# Access Compliance Report

## Public Rights-of-Way

### (Curb Ramps)

Intersection ID: 10019902	Main Street: ARCO_CORPORATE_DR	Cross Street: N/A	Location: N
ADA ID: BFC9F363627B	Ramp Type: PerpDiag	Initial Pass/Fail: Fail	Overall Compliance: No
Severity Score: 21.25			
Codes/Mitigation Info/Possible Solution		Field Measurements/Component Compliance

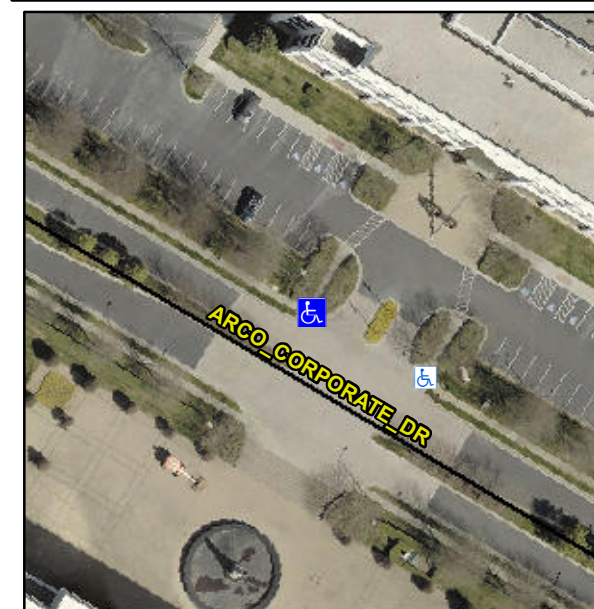
**Remove & Replace Curb Ramp With Two New Directional Ramps or Equivalent.**

**R304.5.1, R304.2.2**

Compliance	Description	Data	Compliance	Description	Data
N/A	Ramp Length (in)	52.0	No	Ramp Slope (%)	10.1
No	Ramp Width (in)	42.0	Yes	Ramp XSlope (%)	1.7
N/A	Flare Type LT	N/A	N/A	Flare Type RT	N/A
N/A	Flare Slope LT (%)	N/A	N/A	Flare Slope RT (%)	N/A
N/A	Flare Traversable LT?	N/A	N/A	Flare Traversable RT?	N/A
N/A	Landing Length (in)	N/A	N/A	DWS Provided?	N/A
N/A	Landing Width (in)	N/A	N/A	DWS Contrast?	N/A
N/A	Landing Slope (%)	N/A	N/A	DWS Length (in)	N/A
N/A	Landing X Slope (%)	N/A	N/A	DWS Full Width?	N/A
N/A	Landing Curb? (Y/N)	N/A	N/A	DWS Offset (in)	N/A
N/A	Shared Landing?	N/A			
N/A	Gutter Ponding?	N/A	N/A	Gutter Slope (%)	N/A
N/A	Gutter Lip Ht (in)	N/A	N/A	Gutter X Slope (%)	N/A
N/A	Painted X Walk1?	No	N/A	Painted X Walk2?	No
	X Walk 1 Direction	To SW		X Walk 2 Direction	To SE
N/A	X Walk 1 Width (in)	N/A	N/A	X Walk 2 Width (in)	N/A
	X Walk 1 Slope (%)	3.0		X Walk 2 Slope (%)	3.1
	X Walk 1 X Slope (%)	1.5		X Walk 2 X Slope (%)	0.9
